SUBJECT: RESULTS OF THE DIABLO CANYON UNIT 1 NATURAL CIRCULATION, BORON MIXING, AND COOLDOWN TEST EVALUATION

Re: Watts Bar Nuclear Plant, Units 1 and 2.

SUBJECT: DIABLO CANYON CONFORMANCE WITH BRANCH TECHNICAL POSITION
RSB 5-1 REGARDING NATURAL CIRCULATION, BORON MIXING, AND COOLDOWN

Figure 3.4 The calculated RCS temperature (20°F/hr cooldown).

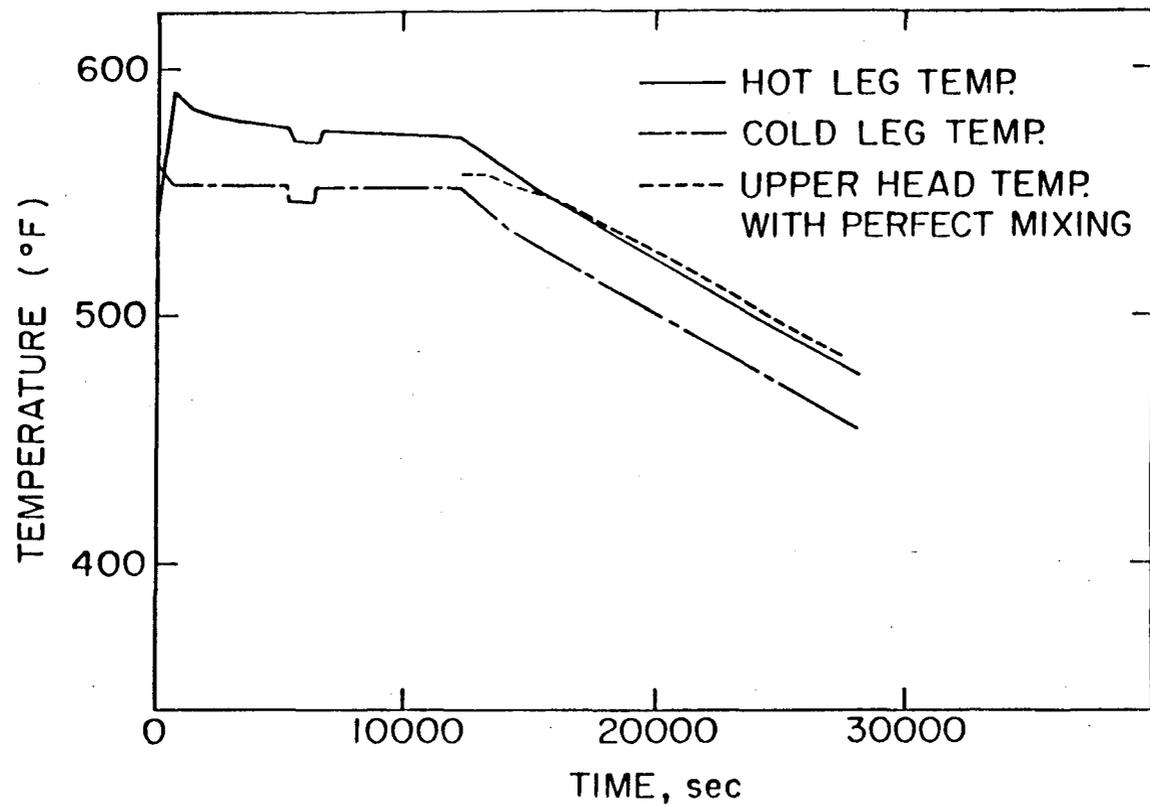
The upper head fluid temperature calculated by the code (20°F/hour cooldown) is shown in Figure 3.4. The calculations indicate that upper head was cooled at about the same rate as the RCS and, thus, maintained the same margin of subcooling as the RCS. This was due to the fact that a substantial bypass flow was calculated by the code cooling the upper head and mixing with the upper head fluid. (Complete mixing was assumed in the upper head for the calculation but the expected effects of flow stratification are assessed in the next section.) Therefore, cooling of the upper head is expected to be substantially less than that indicated by the calculation.

Figure 3.7 Test pressure and pressurizer level.

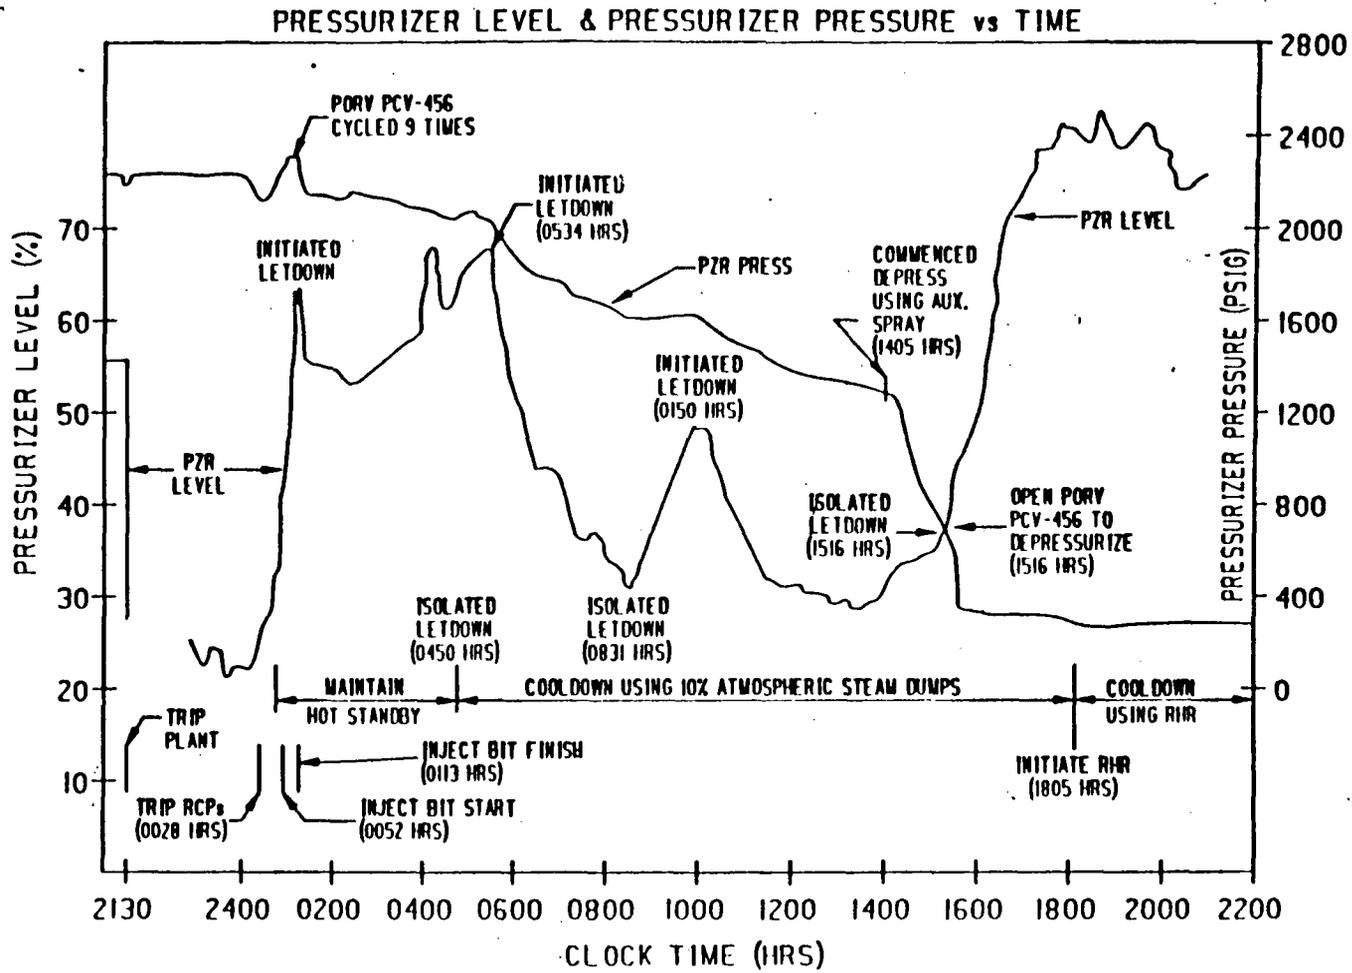
The test pressure (Figure 3.7) was different from the calculated pressure; the calculated pressure showed a steep decline in the beginning due to the shrinkage of the coolant while the test maintained its steady state

pressure after a short blip at the plant trip. This was due to the fact that the pressurizer heaters, which were not safety grade equipment, were used in the test during this period, while they were assumed not available in the calculation. However, a similar pressure drop was also shown in the test when the pressurizer heaters were not available in the test briefly (between 24:00 and 24:30 hours, as shown in Figure 3.7). The calculated pressure and pressurizer level showed a slow increase after the initial drop because a small amount of RCP seal injection (20 gpm) was maintained in the calculation as in the test. Letdown was assumed not available in the calculation since it was not safety graded equipment. This continuous injection of additional mass without letdown would eventually cause the opening of the PORV. Although the ambient heat loss in the pressurizer was modelled in the calculation, the pressure drop due to the heat loss was not enough to compensate for the increase of the pressure due to injection of the RCP seal injection. It was estimated that the RCP seal injection would increase the pressurizer level about 10% each hour.

Figure 3.8 Bypass flow.

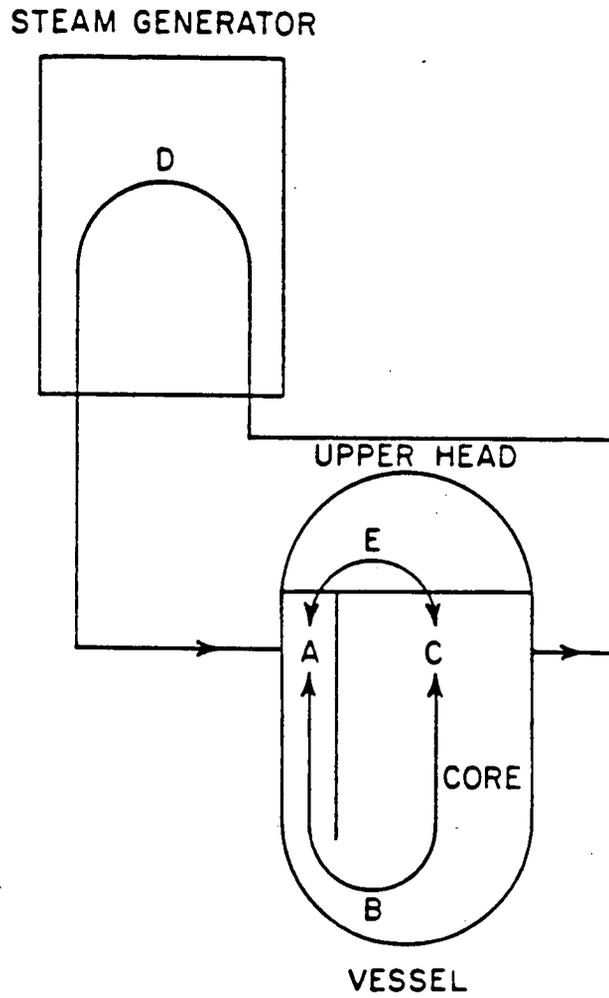
BNL's results appear to be qualitatively correct. The driving force exerted on the bypass flow is the gravity force created by the temperature induced density differences in the RCS loop. As shown in Figure 3.8, there are two buoyancy forces exerted on the flow path AEC acting in opposite directions. One force is created by density differences in the flow path CDA (through steam generator) which forces flow from A to C. The other buoyancy force is created in the flow path ABC (through the core) which forces flow from C to A. In the specific geometry of the Diablo Canyon Power Plant the calculations indicate that the driving force of CDA surpassed that of ABC, thus resulting in the flow from A to C through E. The magnitude of this flow was difficult to confirm by independent calculation, however, since the results are very sensitive to the calculated frictional losses. Based on the calculated bypass flow rate, the upper head fluid would be replaced completely every forty (40) minutes. This relatively large flow and short replacement time would enhance the mixing of fluid in the upper head, thereby promoting cooling and boron mixing in the upper head. However, the mixing of fluid within the upper head region may not be good considering the large amount of guide tube structures in it. The significance of this aspect will be discussed in more detail in Section 4.5.

Figure 3.9 Boron concentration.

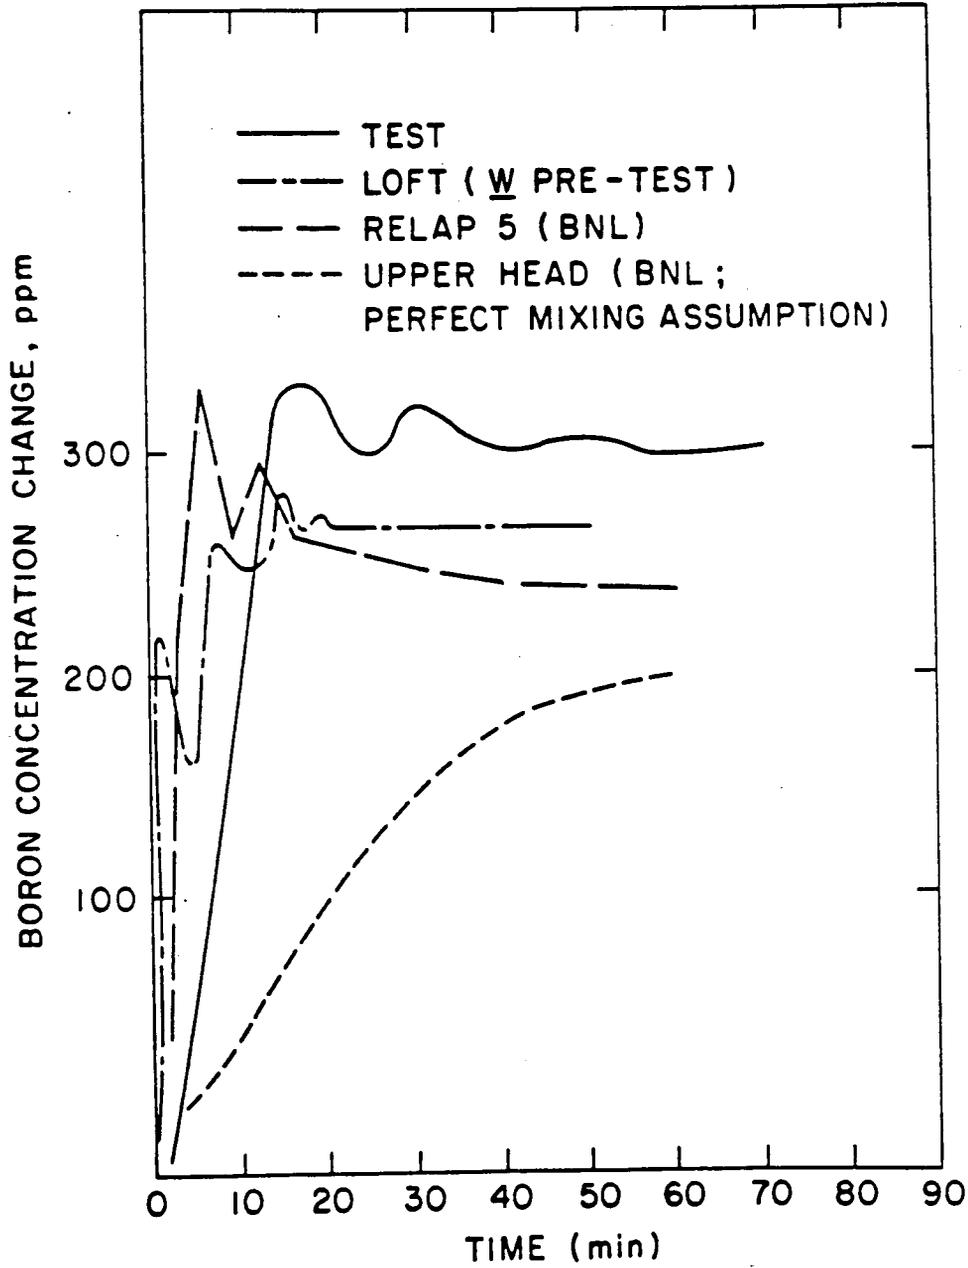
After the natural circulation was established, the boron was injected. A total of 900 gallons of 21,000 ppm borated water was added to the RCS, using the boron injection tank (BIT). Figure 3.9 shows the boron concentrate calculated by the code as well as the actual test result and the pre-test prediction. Also plotted are the calculated boron concentration in the upper head, when boron was mixed evenly in the upper head. Although the rate of increase of the boron concentration differs somewhat between both analyses and the test, all show a sufficiently rapid rise to insure the adequate mixing of boron in the main flow paths of RCS under natural circulation condition.

Figure 3.9 shows that the increase of the boron concentration was slower in the upper head than in the rest of the RCS. Nevertheless, it also reached the average bulk boron concentration in less than one hour. This was due to relatively large bypass flow fraction into the upper head. It should be noted that the boron concentration in the upper head calculated by the RELAP assumes complete mixing. However, the fluid in the upper head appears to be stratified with little or no mixing as discussed earlier. This suggests that there may be some unborated water in the upper head. A similar concern may be raised about the boron mixing in the pressurizer. This point will be further discussed in the next section.

Figure 3.10 RCS pressure and pressurizer level (20°F/hr cooling).

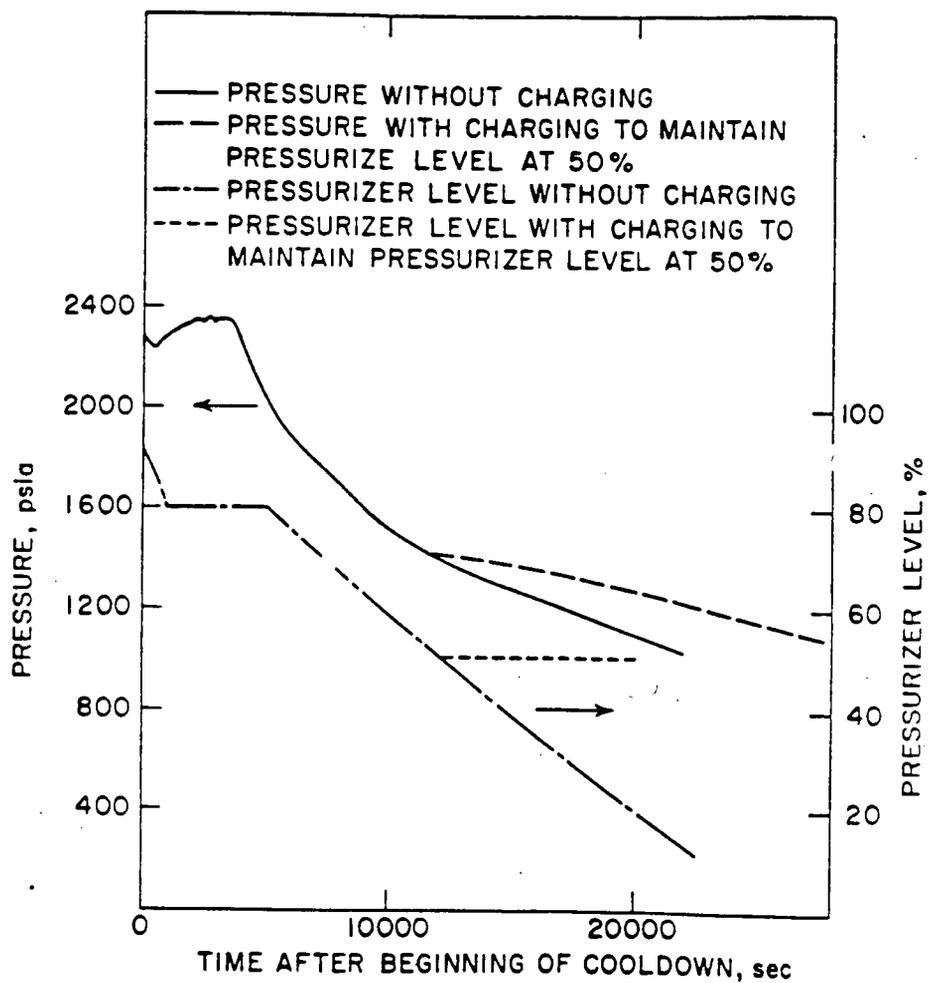
To assess the impact of the RCP injection, an additional calculation was performed without RCP injection. Figure 3.10 showed the gradual pressure decrease as expected. It showed that pressurizer level was also gradually decreasing and indicated that the pressurizer would eventually empty without further operator actions. In practice, the operators would try to maintain the pressurizer level by operating the charging and letdown systems when available. Figure 3.10 shows the pressure estimated when the pressurizer level was maintained at 50%. The RCS pressure still decreased due to the ambient heat loss in the pressurizer. Figure 3.11 compares the calculated RCS coolant temperature with the saturation temperature corresponding to the RCS pressure and indicates that more than 100°F of subcooling was maintained for the RCS during the cooldown period for both the test and the calculation.

Figure 3.12 RCS temperature and saturation temperature with 50°F/hr cooldown.

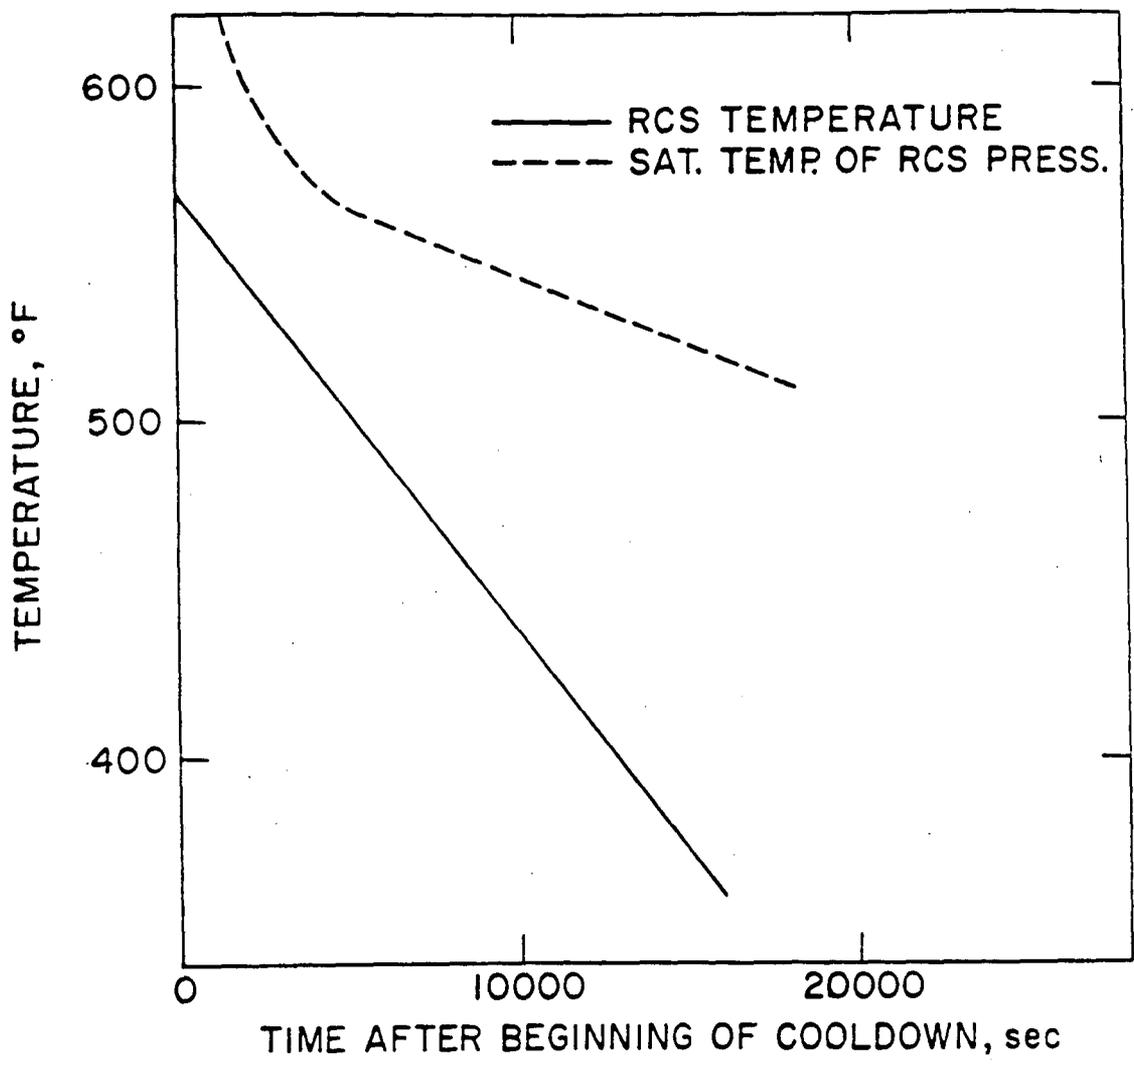
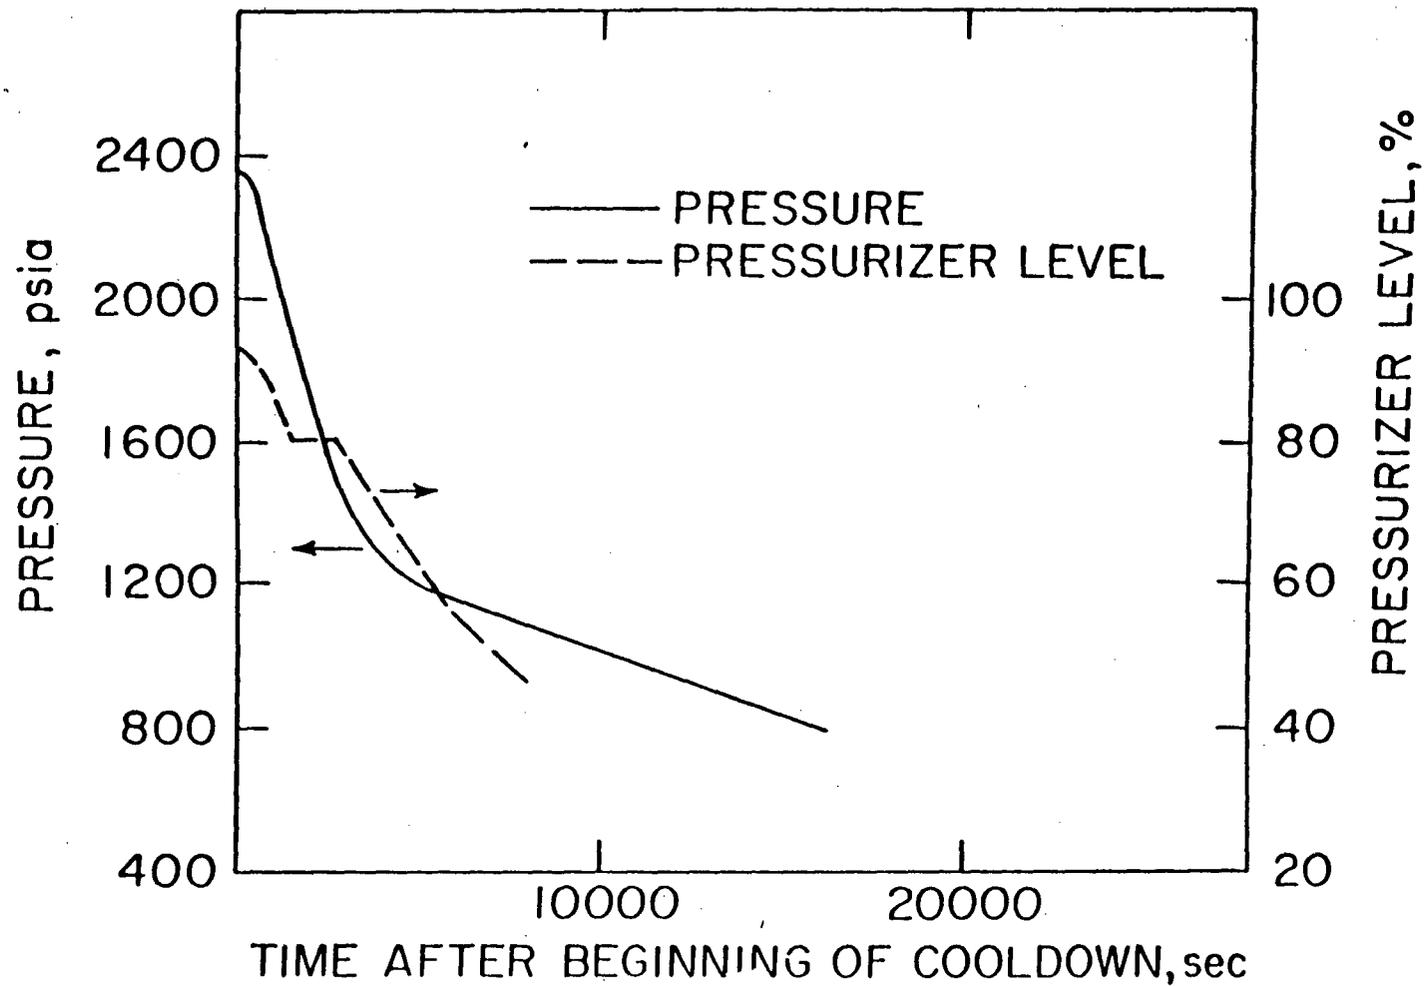
Figures 3.12 and 3.13 give the results of another sensitivity calculation performed with a cooldown rate of 50°F/hour. As expected, the pressure decreased faster than the previous cases even with RCP seal injection since the shrinkage of the coolant was more than the volume of the injected water. During this rapid cooldown, the bulk RCS temperature is adequately subcooled throughout the cooldown, as shown in Figure 3.12.

Figure 3.15 Accumulated cooling water.

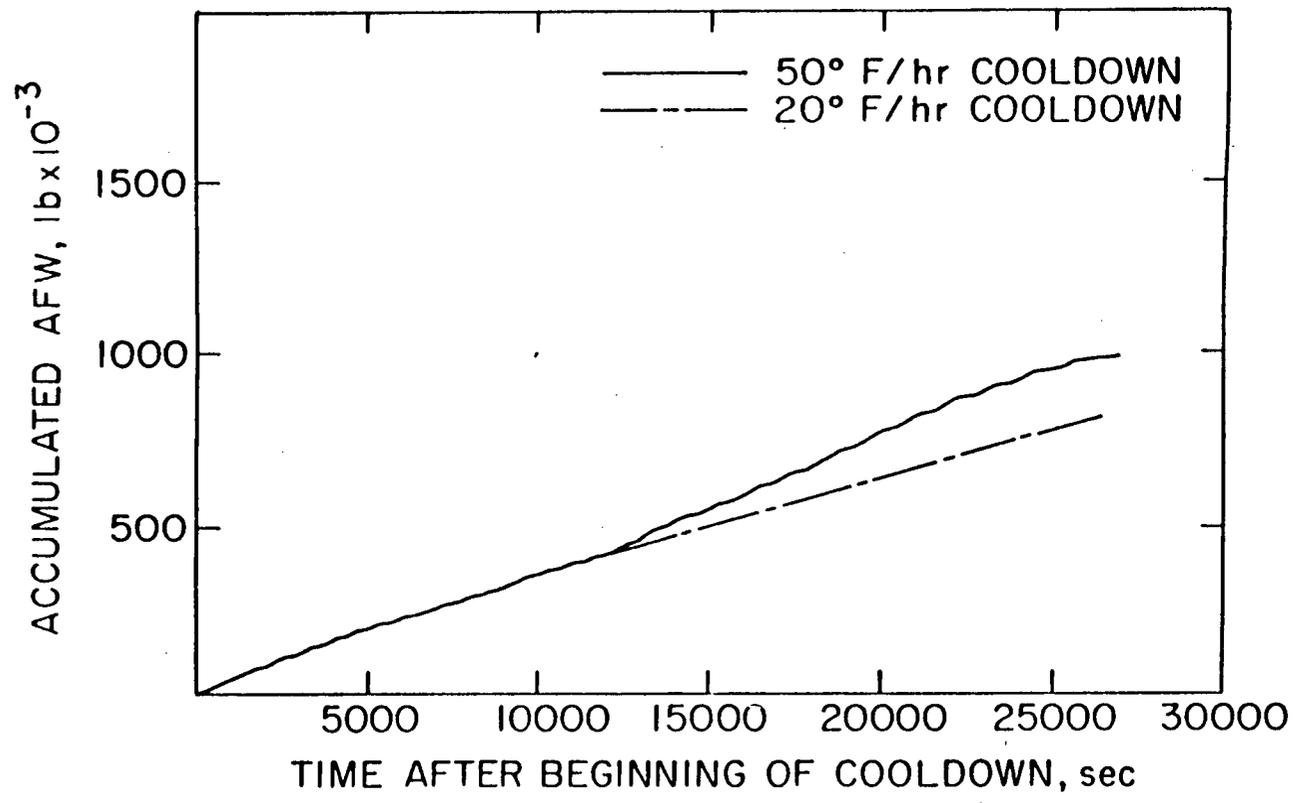
Figure 3.15 shows the accumulated AFW calculated to be used during the cooldown operation. Approximately 120,000 gallons of auxiliary feedwater would be used until the end of cooldown when the cooldown rate was 50°F/hour. This included all the sensible heat of the system to bring the RCS from full power to the cold shutdown condition (including the water and metal structures) and the initial eight hours of decay heat. However, the total cooldown operation may last as long as 50 hours to allow time for upper head cooldown when the CRDM fans are not available as discussed in the previous section. Accounting for the additional decay heat during this period, a total of 360,000 gallons of cooling water may be needed, based on the ANS limiting decay heat. This is less than total water available from the condensate storage tank (CST) and other seismic category I sources (a total of 1,170,000 gallons).
